**Safety note concerning: Deployment bags for reserve parachutes**

**Status: OBLIGATORY**

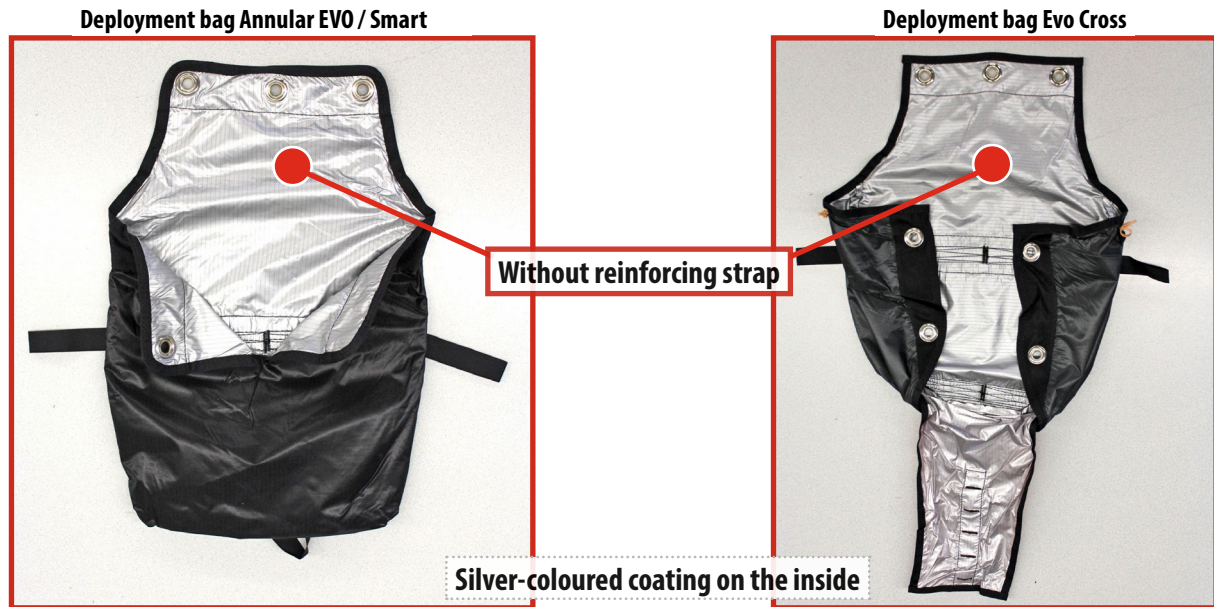
At the seam-line of the isolated upper loop, which is used to attach the deployment handle, a perforation could possibly cause a material weakening of factory delivered deployment bags. This seam-line, if properly processed, has to be able to bear a load of 70 daN. Yet it was proven that a lower strength of this component can occur.

The owners of affected deployment bags are obliged to check before flight, whether the **isolated upper loop** of the deployment bag is in use. If it is in use, the deployment bag needs to be replaced immediately!

If one of the **three loops in a row**, which are placed between the labellings, is in use, the deployment bag does not necessarily need to be replaced. **These three loops don't show any faults and are not concerned by this safety note** (see image on the left).

If the isolated upper loop is in use, **immediate replacement** is obligatory!

If one of the lower 3 loops placed in a row is in use: Replacement should take place latest during the next re-pack of the reserve.

### DEPLOYMENT BAGS NOT CONCERNED

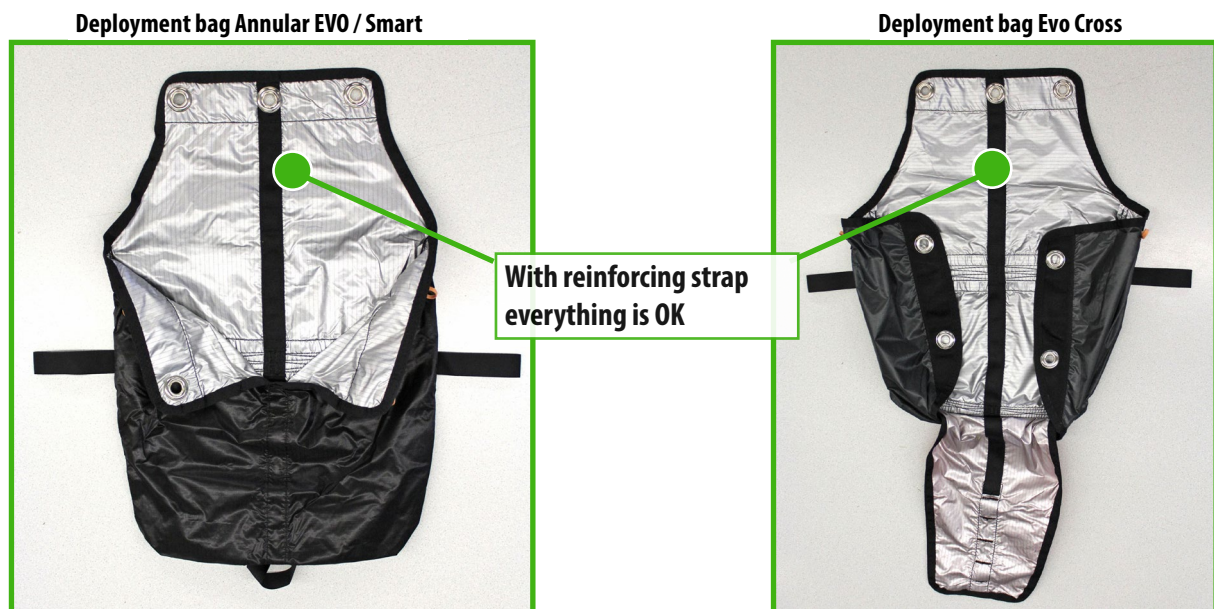
Not concerned are earlier items which can clearly be recognised by the missing silver-coloured coating on the inside. Not concerned are all items which have been delivered as of February 2018. These new deployment bags are clearly marked with a check mark (OK) and can be recognised by the additional reinforcing strap on the inside. Furthermore deployment bags which have been delivered as component of a harness are not concerned.
